DESIGN REVIEW COMMITTEE

February 16, 2022 6:00 PM

4.I. 551 Lake Drive Addition/Remodel

**DEPARTMENT OF PLANNING AND ZONING
PLANNER'S REPORT**

Site Plan

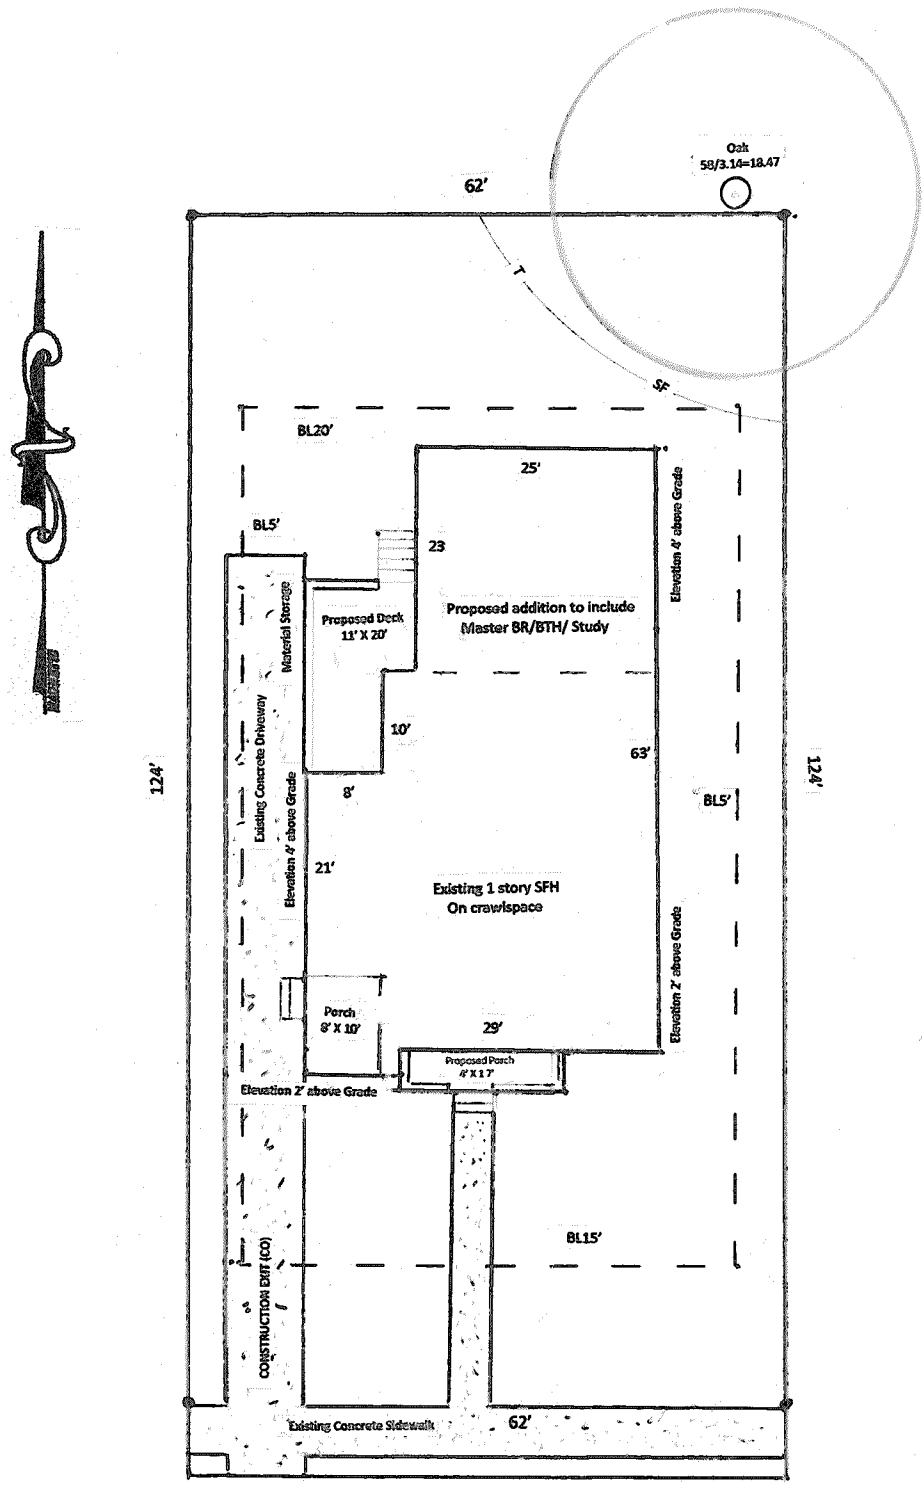
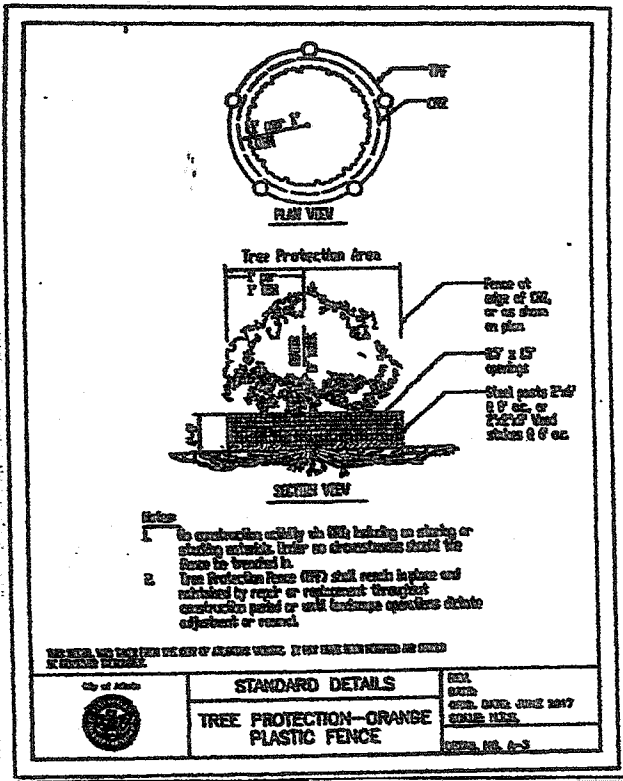
No landscape plan was provided for the addition.

STAFF COMMENT: Mechanical is not shown. Mechanical must be screened.

- Mechanical must be shown and screened if visible from right of way.
- Roof overhang should be a minimum of 1'
- Roof shingle warranty should be specified as 30 years.
- Foundation should be detailed.
- Porch finish not provided.
- Porch as percentage of façade should be detailed. DRC should not that the front porch plus side porch likely meet the 80 to 100% standard however, porches are not connected.
- Clear depth of front porch is 4' not 8'; if acceptable to DRC a design exception is required.
- Distance between columns exceeds 8' on center.
- Column piers do not extend to grade.
- Provide detail for windows to ensure standards are met.
- Provide trim detail (to meet standards).
- Provide sill material.

240 Mt Zion Rd
New Home
Exterior Elevations

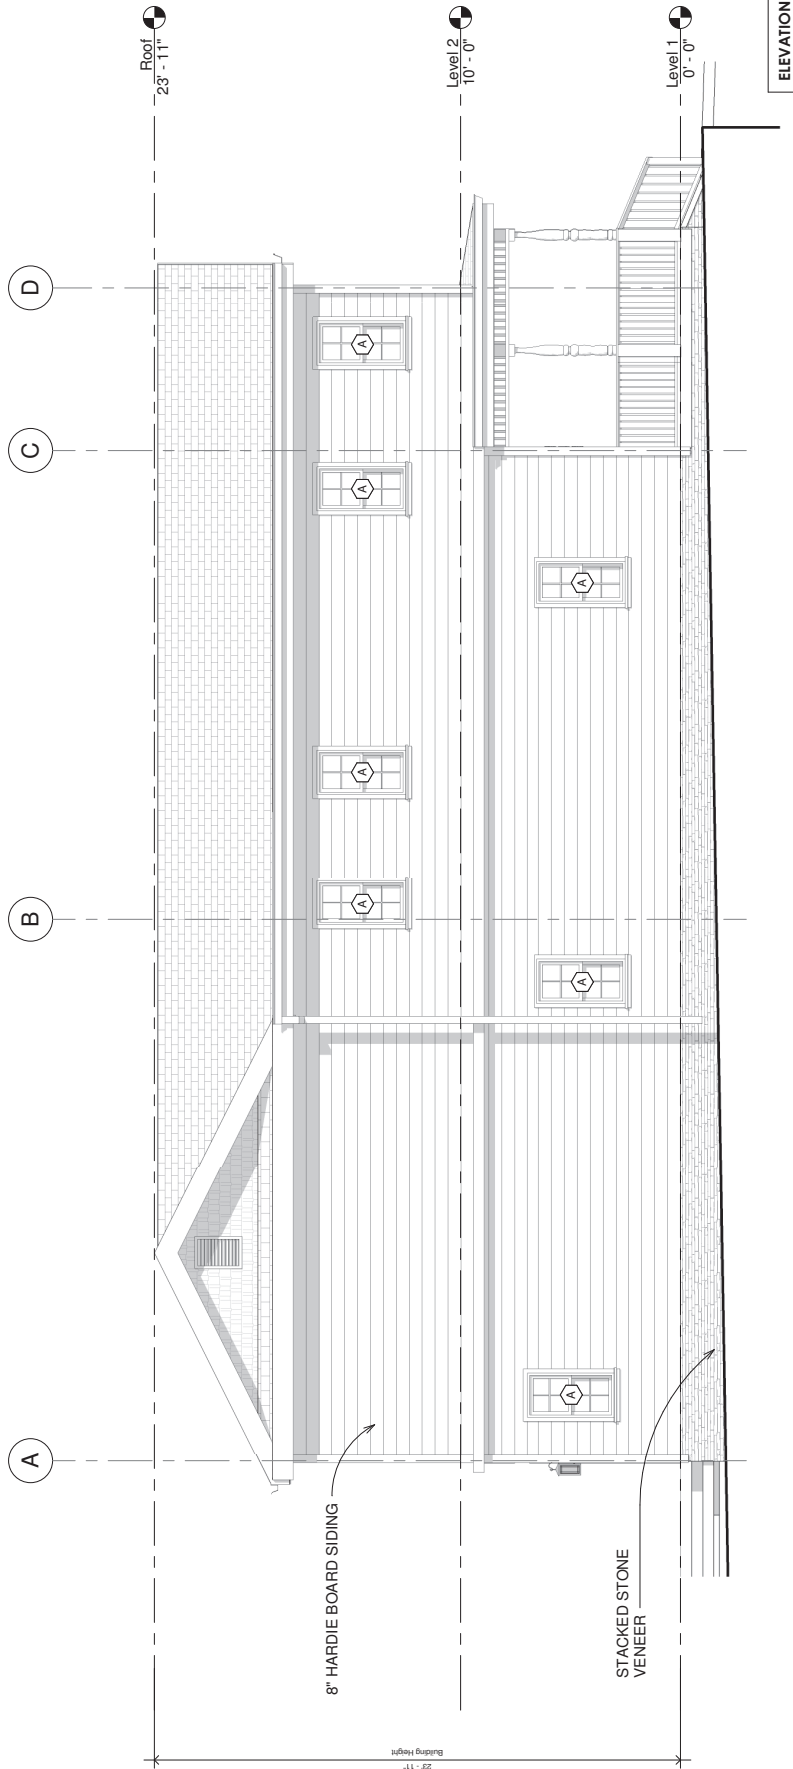
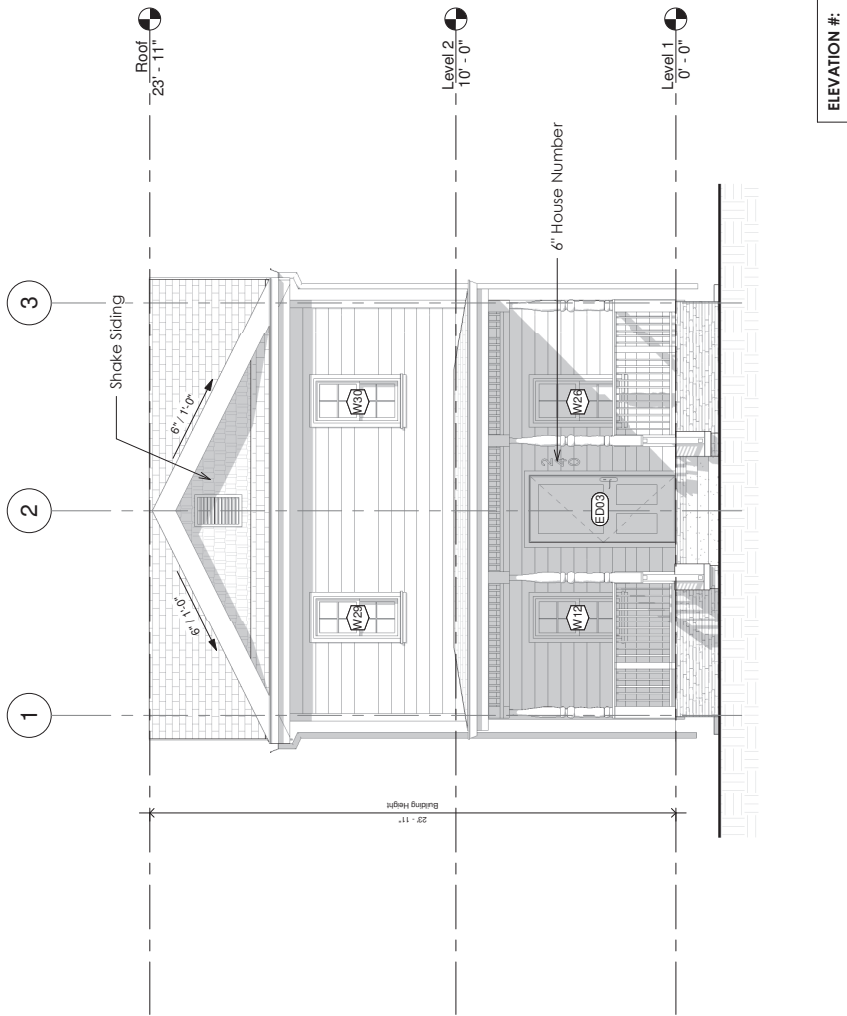
STAFF COMMENT: Ensure recess is a minimum of 2 in on bottom sash. No GBG. Windows shall be provided for a minimum of thirty (30) percent and a maximum of 50 percent of the total street-facing facade of the principal building, with each facade and story calculated independently. Second floor windows do not meet requirement.
